DFCU SITE PLAN 10-49

Consideration of the request of DFCU Financial for Preliminary Site Plan approval. The subject property is located in Section 24, on the north side of Ten Mile Road, west of Haggerty Road, in the OS-1, Office Service District. The subject property is approximately 2.39 acres and the applicant is proposing to construct a 4,200 square foot credit union with drive-through facilities.

PLAN REVIEW CENTER REPORT

SP10-49

Excerpt of City-Approved Site Plan for Jaguar at Novi, 4-27-01
(SP#00-49)

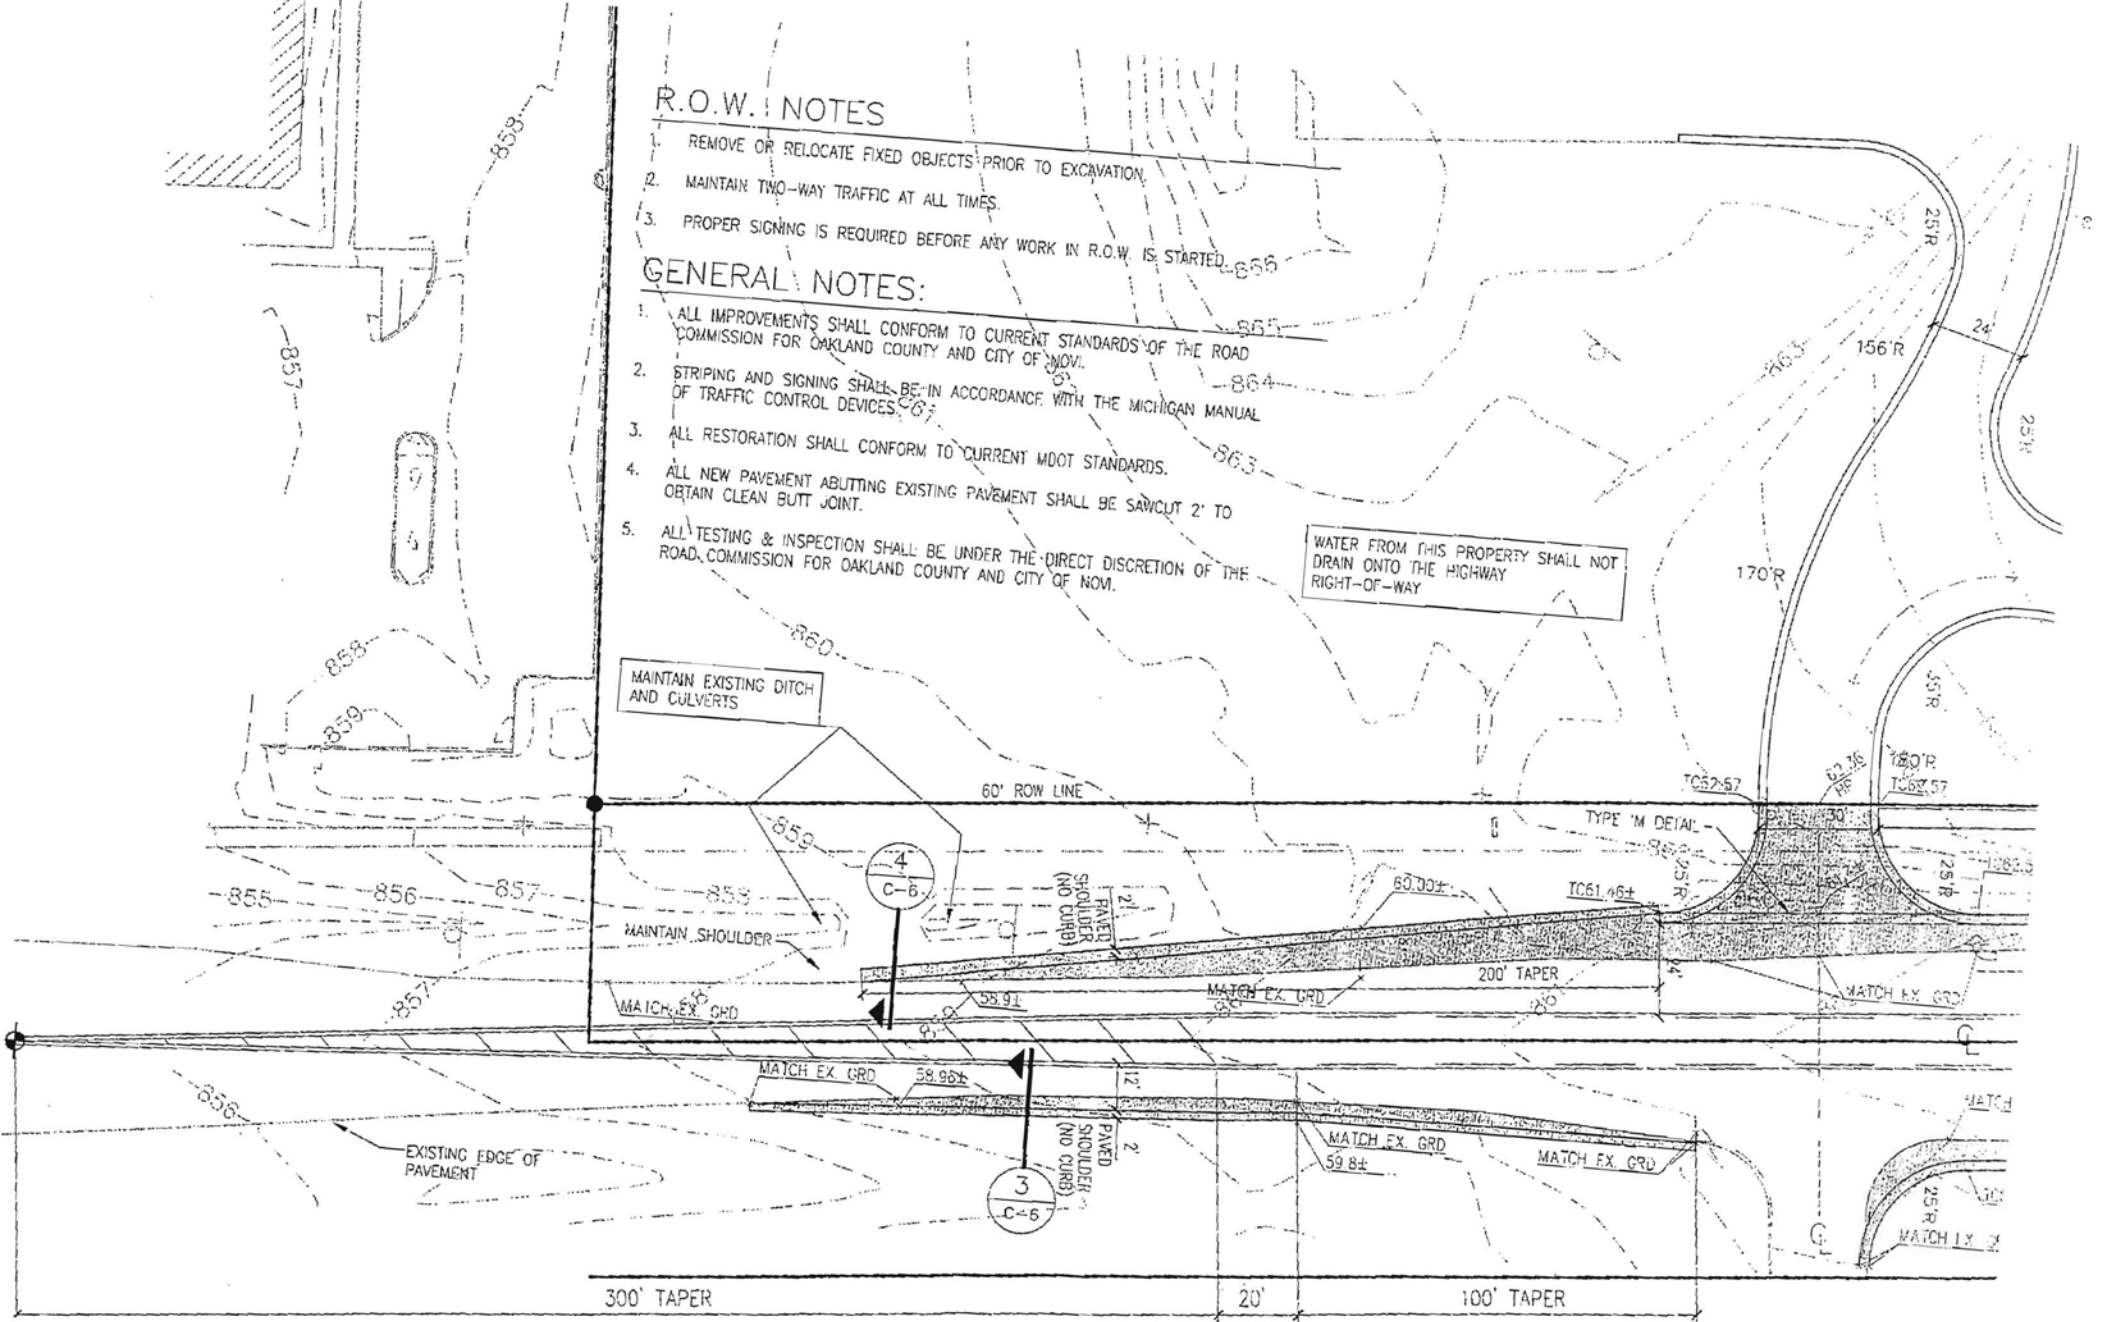
7. No public road improvements have been proposed. For the record, we note that the City-required improvements for Jaguar of Novi (excerpts attached) would have provided a (City- and Road Commission-standard) 150-ft long left-turn lane in advance of the existing driveway now proposed to be shared by the credit union as well as Jaguar and Excel. The second attached aerial photo (Figure 2) shows, however, that the Jaguar-sponsored road improvements actually constructed start the left-turn lane much closer to the subject drive. There appears to be space in the full-width left-turn lane for only one vehicle to stack for the driveway, rather than the six provided by a 150-ft long left-turn lane.

8. Per City standards, full-time, two-way vehicular access to a site should normally be provided by external and/or internal drives at least 24-ft wide. Indeed, the approved site plan for Jaguar of Novi (excerpts attached) shows the shared driveway just north of Jaguar's west access being widened to 24 ft (back-of-curb to back-of-curb). DFCU's plan, however, shows the existing drive at that location being only 21 ft wide (back-to-back).
